STAFF REPORT  
(Final Plat)

CASE NUMBER: S/D 96-52 JOHN AND DEBRA WILLIAMS ADDITION

OWNER/APPLICANT: John Williams, 413 St. Paul, Wichita, KS 67203

# Sketch Plan John and Debra Williams Subdivision

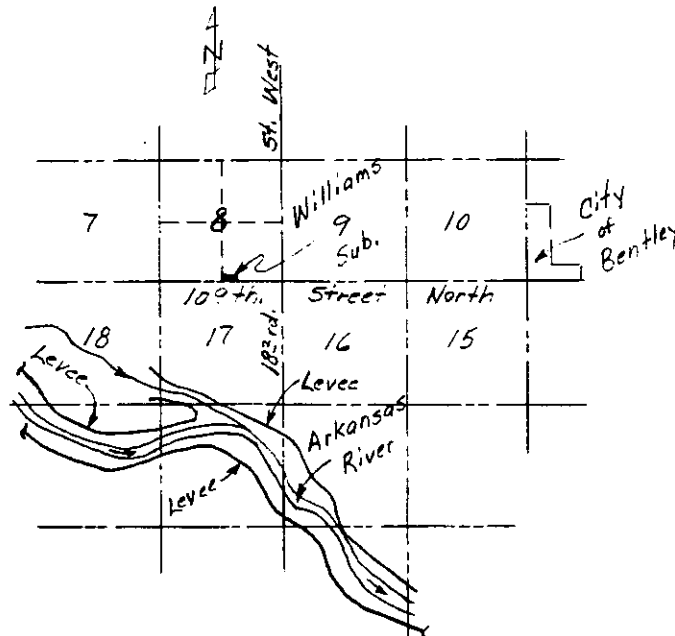
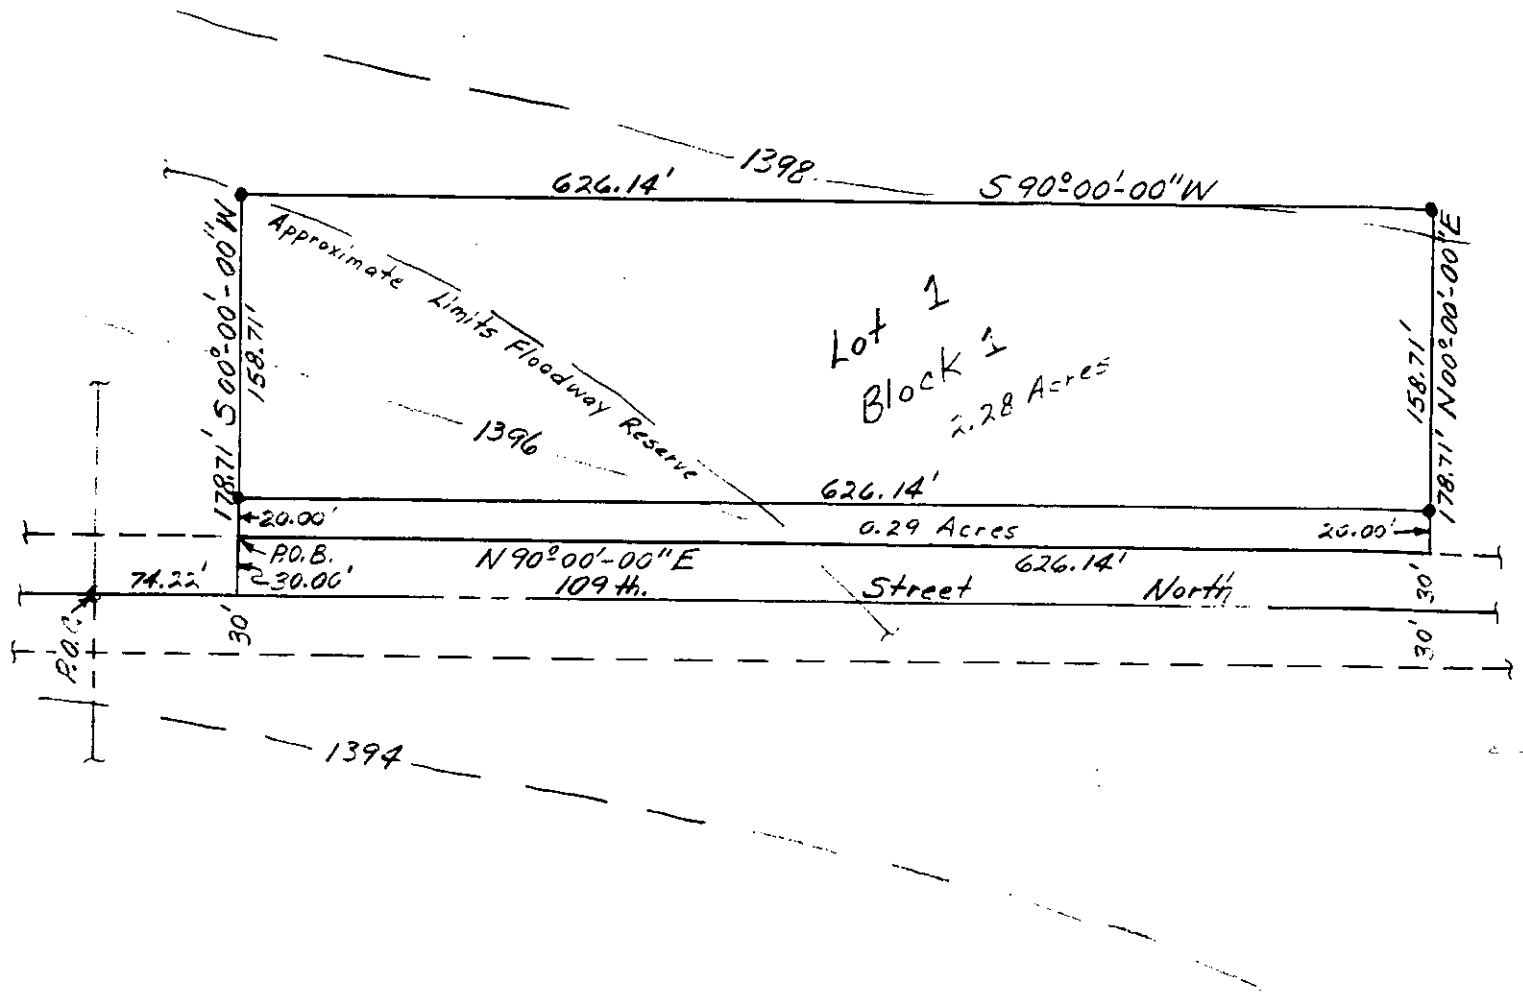
- B. The applicant shall guarantee any drainage improvements required by the platting of this property.
- C. On the final plat tracing, this plat's name shall employ standard terminology. That is, the term Addition shall be used rather than Subdivision.

- D. On the final plat tracing, the face of the plat shall clearly label the area of street dedication and this area shall be shown in a more specific manner from the adjoining lot. Dashed lines, fainter lines, etc. should be used for the 20-foot dedication so as to make it distinctly separate from the adjoining lot. The .29 Acre noted in the area of dedication shall also be deleted.

- E. The final plat tracing shall indicate a 30-foot building setback to 109th Street North.
- F. The face of the plat shall also note the dedication of the access control as stated in the platlor's text.

- G. On the final plat tracing, a tie point shall also be shown on the face of the plat.
- H. County Engineering needs to indicate if a minimum building pad elevation is required for this site. If required, both the platlor's text and face of the plat shall note such an elevation. Also, both an on-site and off-site benchmark shall be shown.

- I. On the final plat tracing, line 5 of the platlor's text shall be corrected to state...denoted on said plat....
- J. The applicant's agent is advised that a platting binder is required with submission of the final plat. This binder shall be submitted with the tracing and this plat shall be subject to review of the binder and any relevant conditions found by such a review.
